April 6, 1982

Enclosed is our response to your letter to H. G. Parris dated February 12, 1982 regarding the request for additional information on hydrogen control for our Sequoyah Nuclear Plant. If you have any questions concerning this matter, please get in touch with J. E. Wills at FTS 858-2683.

ENCLOSURE  
RESPONSE TO NRC REQUEST FOR ADDITIONAL INFORMATION  
REGARDING HYDROGEN CONTROL  
SEQUOYAH NUCLEAR PLANT

Figure 2.3-1

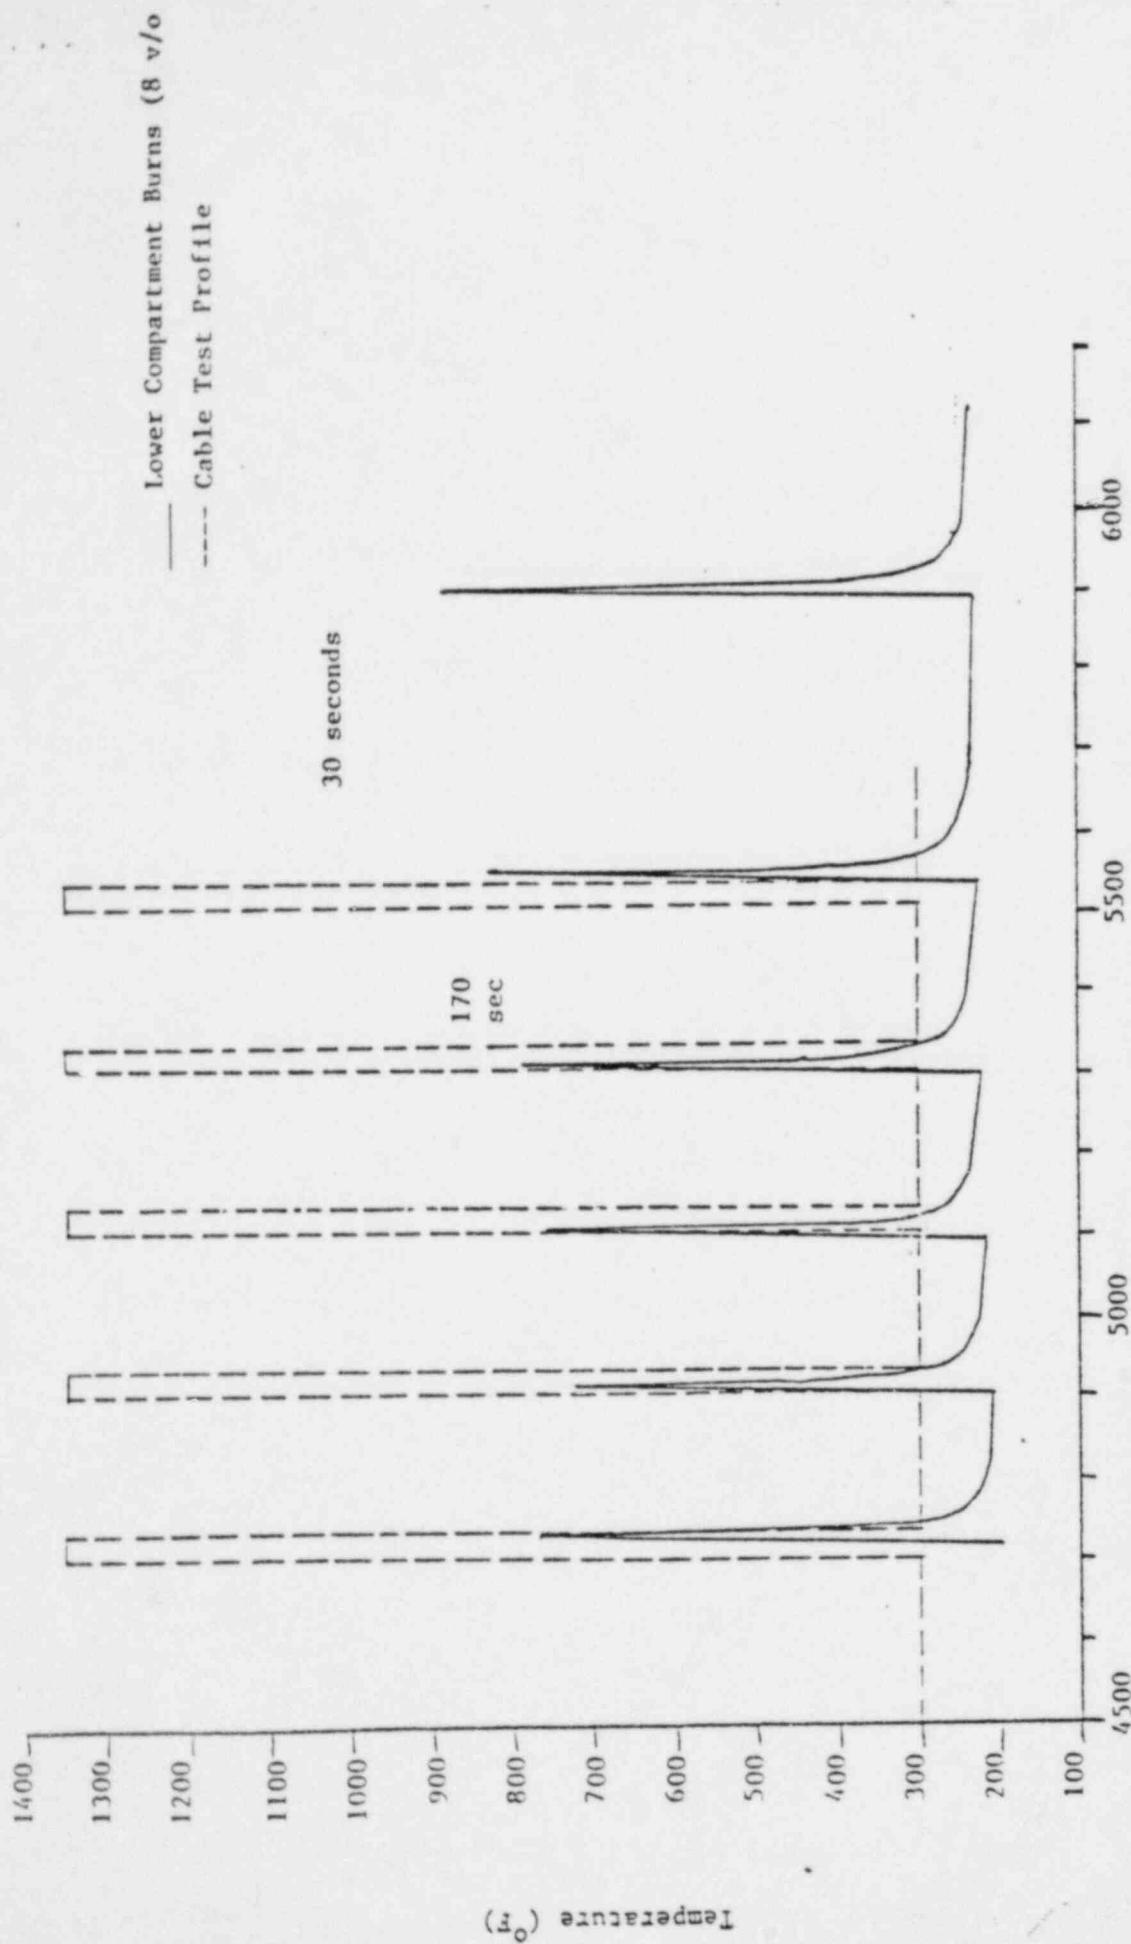
Question 7. Provide Table 2.1 and Figure 2.3-1 missing in your submittal.

Response: The requested information is provided in attachment 1.
